The proposed alterations & adaptations to the present ground & basement floor apartment of 15a Well Walk, comprise major internal changes to the present layout, plus the extension at the rear of the property of the apartment by 'building-out' part of the present rear lower ground patio area for a new study & a new bay window above at ground level to create a new ground level view for the relocated living area overlooking the existing private communal gardens of the main house.

### 2.2 PLANNING OFFICERS REPORT DATED 6<sup>TH</sup> MAY 2012

## 2.3 RESPONSE TO PLANNING OFFICERS REPORT

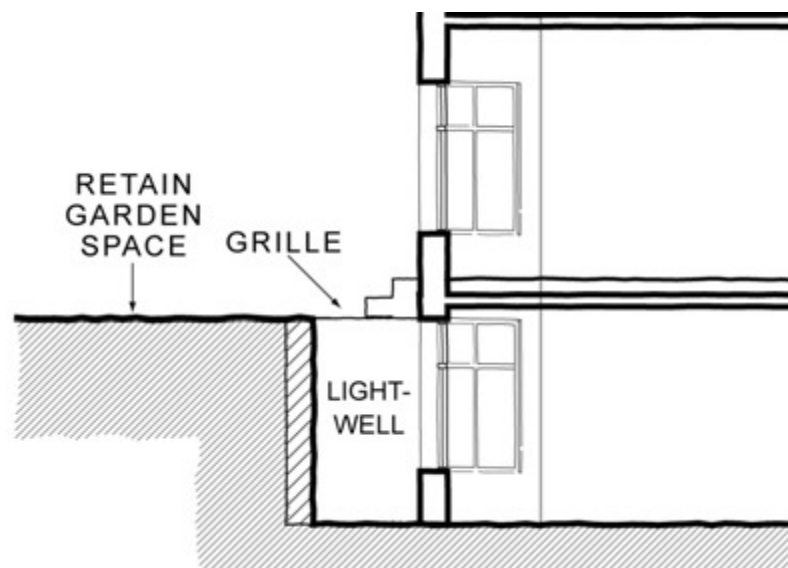
2.71 A lightwell to the side or rear of a property is often the most appropriate way to provide a means of providing light to a new or extended basement development, and can often provide a link to the rear garden. Lightwells to the side or rear of a property should be set away from the boundary to a neighbouring property.

**Response** – A Lightwell/ courtyard is proposed as indicated in the guidance notes except without the horizontal safety grille as shown in the above extracts as the lightwell is guarded by the existing communal garden railings & is sized to provide daylight to the new study & existing bedroom & accommodate a small spiral emergency staircase.
